UNITED STATES PATENT AND TRADEMARK OFFICE

10/737,355

Brent R. Jones

Office Action Summary

FIG. 4

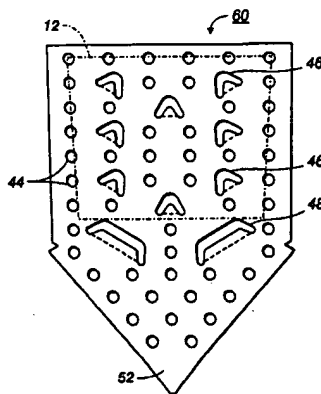
- {claim 1} A drip plate for use in a phase change ink jet printer using solid ink, comprising: an upper portion; and a lower pointed portion, wherein the lower portion is not coplanar with the upper portion (figure 4; column 6, lines 65-67)

- {claim 12} at least one anchor tab extending from the second side of the drip plate located near the center of the plate (figure 4, reference 46)
- {claim 13} wherein the anchor tabs are arranged in pairs and wherein each pair is arranged substantially symmetrically about a vertical center line (figure 4, reference 46)

- {claim 14} a silver strainer located near a lower edge of the drip plate (figure 4, reference 48)
- {claim 15} An ink loader (figure 3)
- {claim 16} An ink loader for a phase change ink printer (figure 3), comprising: at least one channel having an entry end and an exit end (figure 3, reference 25A-D); a melt assembly, which includes a drip plate including an upper portion

- {claim 23} wherein the heating element is a closed loop heater (figure 3, reference 29A-D)
- {claim 26} wherein the melt plate includes at least one anchor tab extending from the second side of the drip plate (figure 4, reference 46)

- {claim 27} wherein the melt plate includes a silver strainer located near a lower portion of the drip plate (figure 4, reference 48)

FIG. 3

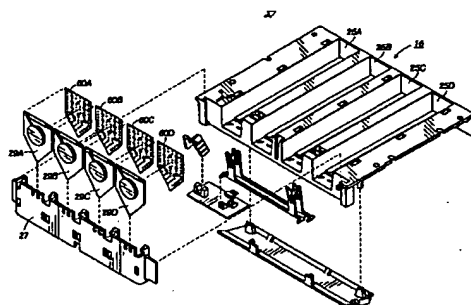
- {claim 2} wherein a heating element is bonded to a first side of the upper portion (figure 3, reference 29A-D)

- {claim 3} wherein the heating element is a closed loop heater (figure 3, reference 29A-D)
- {claim 6} wherein the drip plate is made from metal (column 7, lines 16-17)

having substantially flat upper first and second sides, and a lower portion having substantially flat lower first and second sides, wherein the lower portion is not coplanar with the upper portion (figure 3, reference 60A-D; column 6, lines 65-67); a melt plate fastened to the upper second side of the drip plate; and a heating device thermally connected to one of the melt plate and the drip plate (figure 3, reference 29A-D)

- {claim 17} further comprising an adapter to position the assembly relative to the at least one channel (figure 3, reference 27)
- {claim 18} wherein at least one of the drip plate and the melt plate is made from nonferrous metal (column 7, lines 16-17)

- {claim 19} wherein at least one of the drip plate and the melt plate is made from aluminum (column 7, lines 16-17)
- {claim 22} wherein the heating element is bonded to the first side of the upper portion of the drip plate (figure 3, reference 29A-D; broad interpretation used of heating element being bonded to drip plate through melt plate)
